**[Docket No. FAA-2020-0442; Project Identifier AD-2020-00260-E; Amendment 39-21640; AD 2021-14-13]**

#### **Airworthiness Directives; Pratt & Whitney Turbofan Engines**

**ACTION:** Final rule.

**Figure 1 to Paragraph (g)(1)(iii) – Crack Inspection Critical Areas**

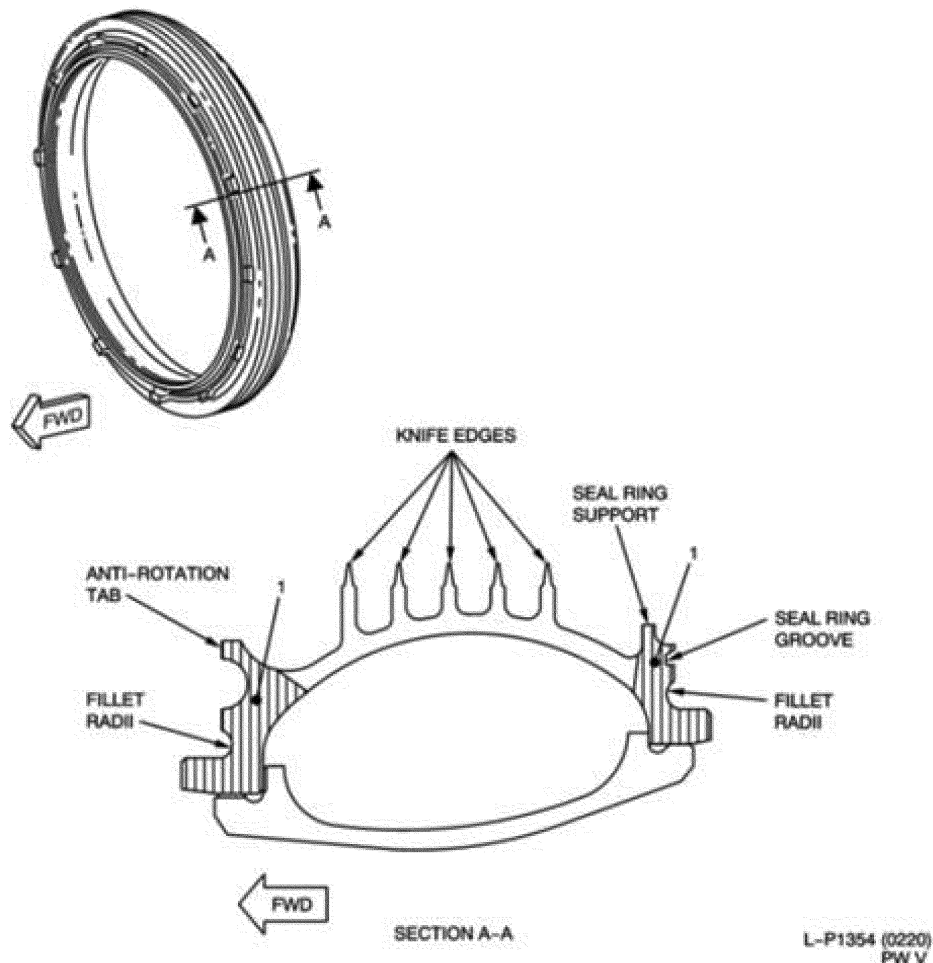
Delta commented that individual part serviceability should not depend on the inspection results of other parts. Delta also commented that if inspections are not possible which would allow the mating HPT 1st-stage disk or the HPT 2nd-stage hub to be deemed serviceable, independent from inspection status of the HPT 2nd-stage air seal assembly, then the manufacturer should revise the engine manuals to clarify that the mating HPT 1st-stage disk or HPT 2nd-stage hub cannot be made serviceable unless an inspection of the HPT 2nd-stage air seal assembly indicates it is free of cracks. Delta stated that this would remove the possibility that the mating HPT 1st-stage disk or HPT 2nd-stage hub would be made serviceable and then installed in an engine before the HPT 2nd-stage air seal assembly is inspected.

MTU requested clarification regarding whether the mating HPT 1st-stage disk or HPT 2nd-stage hub needs to be replaced if a crack is found after performing the inspections proposed by paragraph (g)(2)(iii) of the NPRM (paragraph (g)(1)(iii) of this AD), or if both the mating HPT 1st-stage disk and HPT 2nd-stage hub need to be replaced.

Delta and MTU requested that the FAA clarify the location of the forward and aft edges of the HPT 2nd-stage air seal assembly. Delta asked if the forward edge is the barrel section forward of the #1 knife-edge or any part that extends beyond the barrel section.

The FAA did not revise this AD in response to this comment. A crack, as identified in the shaded regions of Figure 1 to paragraph (g)(1)(iii) of this AD (Figure 1), which extends towards the knife-edge region of the HPT 2nd-stage air seal assembly, impacts the serviceability of the mating HPT 1st-stage disk and the HPT 2nd-stage hub. A crack identified in the shaded region of Figure 1 of this AD of the HPT 2nd-stage air seal assembly results in the requirement to remove the HPT 2nd-stage air seal assembly, mating HPT 1st-stage disk, and HPT 2nd-stage hub.

If a crack is found as identified in the shaded region of Figure 1 to paragraph (g)(1)(iii) of this AD (Figure 1) that extends toward the knife-edge region of the HPT 2nd-stage air seal assembly, this AD requires replacement of the HPT 2nd-stage air seal assembly, mating HPT 1st-stage disk, and HPT 2nd-stage hub.

The FAA removed references to “forward edge” and “aft edge” of the HPT 2nd-stage air seal assembly from this AD. In their place, the FAA added Figure 1 to paragraph (g)(1)(iii) of this AD to specify the locations of the HPT 2nd-stage air seal assembly that require inspection for cracks.

(iii) During the visual inspection or FPI required by paragraph (g)(1)(i) of this AD, if a crack is found in the shaded regions of the HPT 2nd-stage air seal assembly identified in Figure 1 to paragraph (g)(1)(iii) of this AD (Figure 1), which extends towards the knife-edge region of the HPT 2nd-stage air seal assembly, remove the HPT 2nd-stage air seal assembly, mating HPT 1st-stage disk, and HPT 2nd-stage hub from service, and replace the parts with parts eligible for installation. In order to return the mating HPT 1st-stage disk and HPT 2nd-stage hub to service, the inspections of the HPT 2nd-stage air seal assembly cannot reveal a crack identified in the shaded regions of Figure 1, which extends towards the knife-edge region.
